AREA TOPOGRAPHICAL SURVEY		
PROPOSED CONVOCATION CENTER ARKANSAS STATE UNIVERSITY ONESBORO, ARK.		
PREPARED BY: HAYWOOD KENWARD & ASSOCIATES, INC. CIVIL Engineering & Surveying Jonesboro, Ark.	DATE: 10-83	SCALE: 1"=100'
DRAWN BY: J.K.		1:1

A.S.U. CONVOCATION CENTER

SITE PLAN

7/25/84

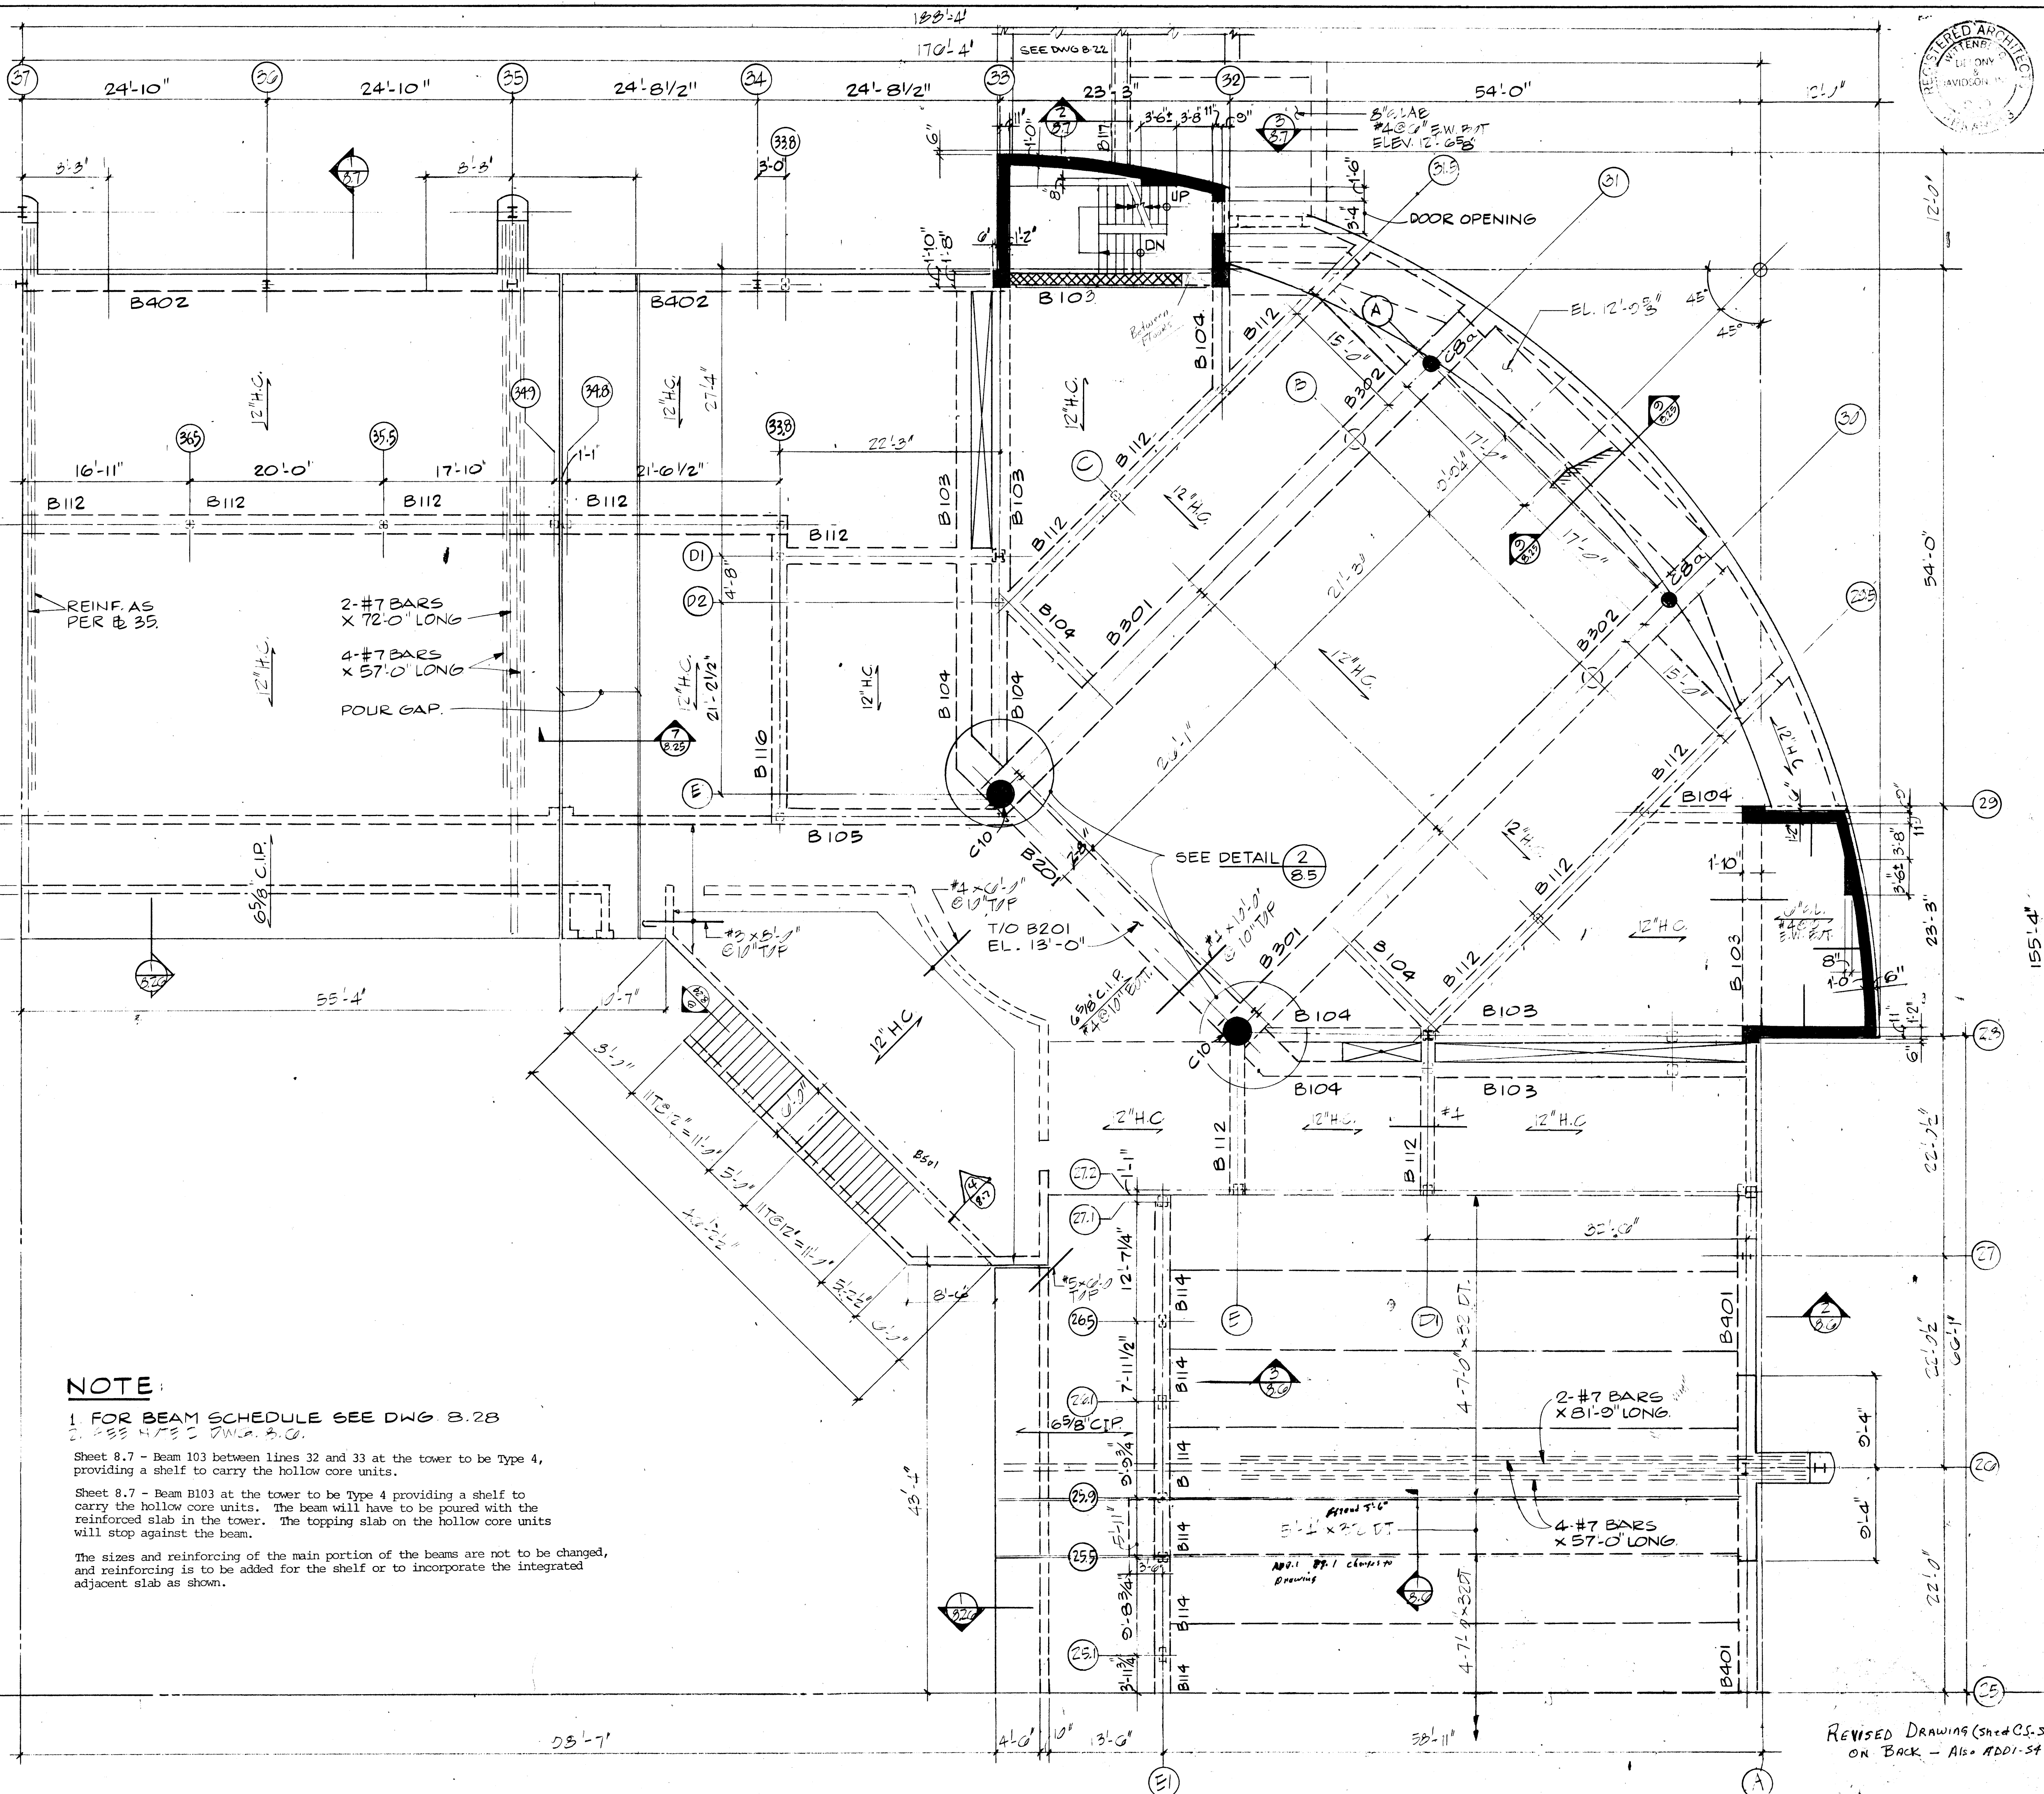
NOTE:
 1 FOR BEAM SCHEDULE SEE DWG 8.28
 2 SEE DWG 8.28
 Sheet 8.7 - Beam 103 between lines 32 and 33 at the tower to be Type 4, providing a shelf to carry the hollow core units.
 Sheet 8.7 - Beam B103 at the tower to be Type 4 providing a shelf to carry the hollow core units. The beam will have to be poured with the reinforced slab in the tower. The topping slab on the hollow core units will stop against the beam.
 The sizes and reinforcing of the main portion of the beams are not to be changed, and reinforcing is to be added for the shelf or to incorporate the integrated adjacent slab as shown.
